# TOLEDO-LUCAS COUNTY PLAN COMMISSIONS

DATE: April 13, 2018  
REF: SUP-12002-17

TO: President Matt Cherry and Members of Council, City of Toledo  
FROM: Toledo City Plan Commission, Thomas C. Gibbons, Secretary  
SUBJECT: Special Use Permit for a gas station and grocery store at 3516 Airport Highway

# SITE PLAN (REVISED)

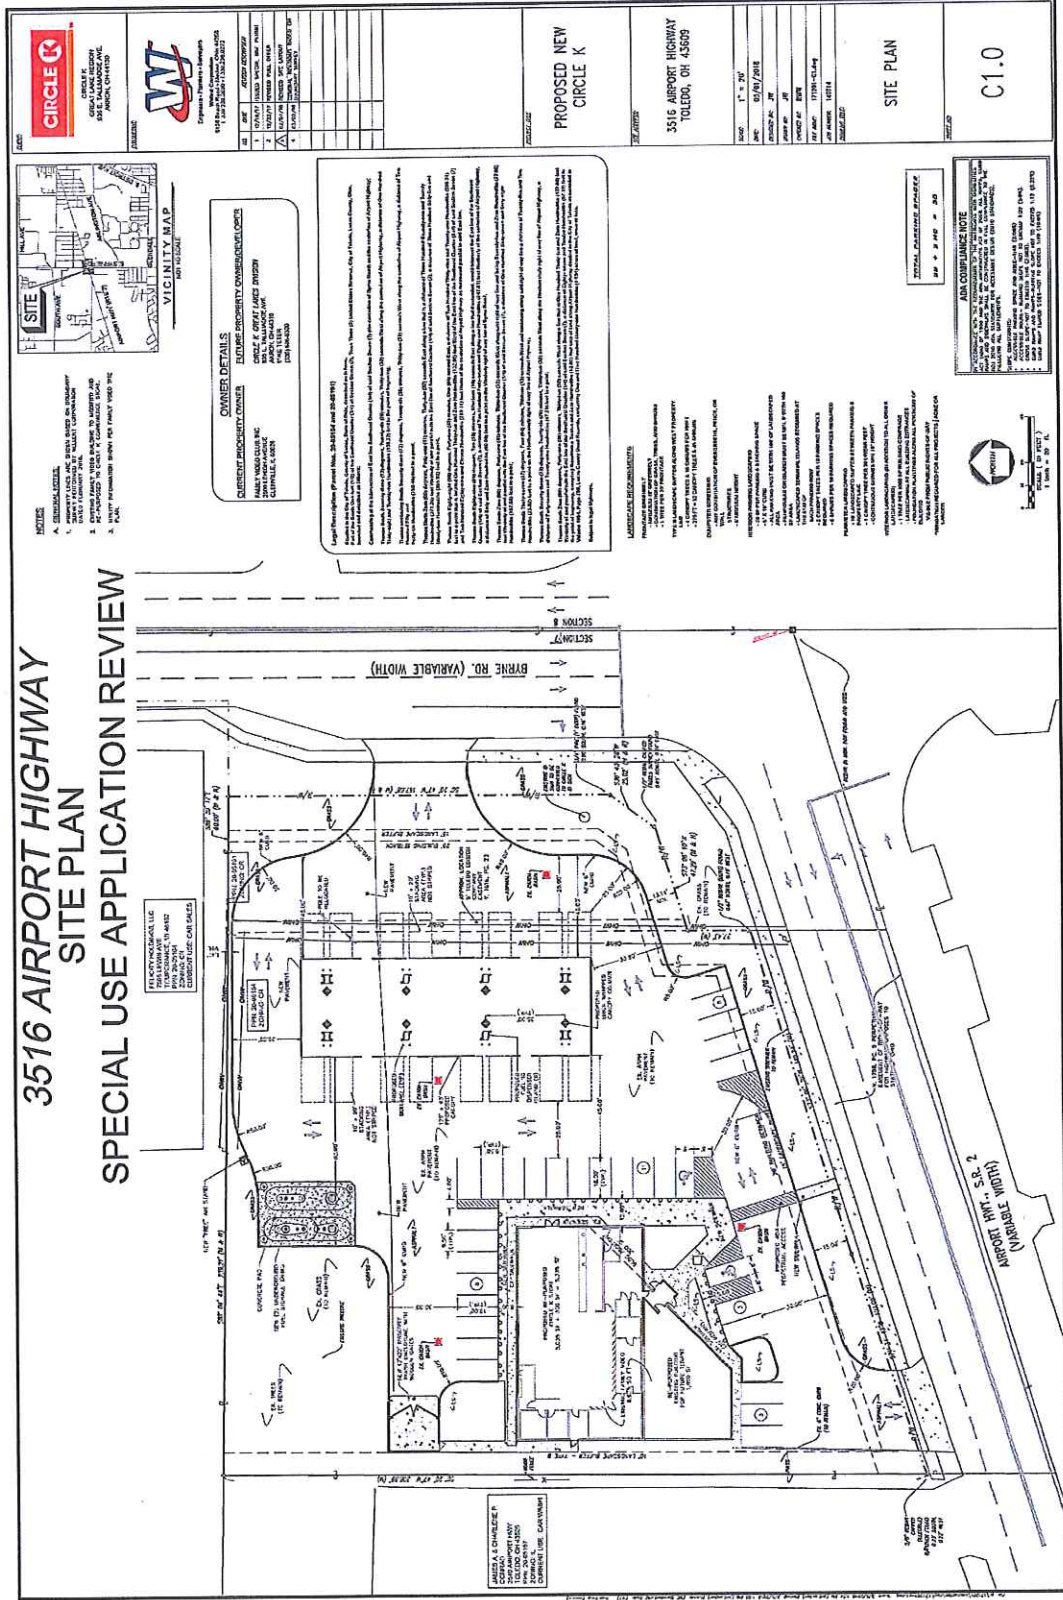
30. All subject lots shall be combined so that the development occupies one (1) parcel.
31. Dumpster location(s) shall be clearly defined, have a concrete pad and be surrounded by an enclosure constructed of high quality materials. Arborvitae, as indicated on the landscape plan shall be maintained around the dumpster indefinitely. **(Dumpster enclosure and landscaping is acceptable as depicted on site plan).**

32. Dumpster/Trash Receptacle Screening states that a dumpster may not be in any required setback or landscape buffers and shall be located as far away from residential areas as possible. **(Acceptable as depicted on site plan).**

33. All four (4) sides of the dumpster must be screened and screening must be a minimum height of six (6) feet in height. Screening materials can be any combination of evergreen plantings, fence or wall structure. Screening should be incorporated into access to the dumpster by using a wooden fence or other opaque device to serve as a gate. **(Acceptable as depicted on site plan).**

34. Off-street parking and loading spaces, parking lots, maneuvering areas, aisles and driveways must be surfaced with concrete, bituminous asphalt, or other dust-free material other than gravel or loose fill, and be graded to drain all surface water towards the interior of the parking lot or to a stormwater treatment facility subject to the regulations approval of the Department of Public Utilities. **(Acceptable as depicted on site plan).**

35. All spaces reserved for the use by persons with physical disabilities shall adhere to the standards outlined in TMC§1107.1700. **(Acceptable as depicted on site plan).**

36. Bicycle parking slots shall be provided pursuant to Off-Street Parking Schedule "A" (TMC§1107.0300). **(Not depicted on site plan).**

37. Whenever a parking lot extends to a property line, sidewalk, planting strip, or building, a wheel stop device consisting of a concrete stop, a permanent concrete curb, an expanded sidewalk or other suitable restraint as approved by the Planning Director must be installed to prevent any part of a parked motor vehicle from extending beyond the property line, overhanging a pedestrian walkway or sidewalk, or damaging any structure or landscaping (TMC§1107.1907(A)) **(Acceptable as depicted on site plan).**

40. Pump islands shall be set back a minimum of 15 feet from the property line (TMC§1104.0903(B)). **(Acceptable as depicted on the submitted site plan).**

44. Free air (with the capability of filling standard automobile tires), water, and restrooms shall be provided and maintained during operating hours of the station (TMC§1104.0903.D). **(Acceptable as depicted on site plan);**
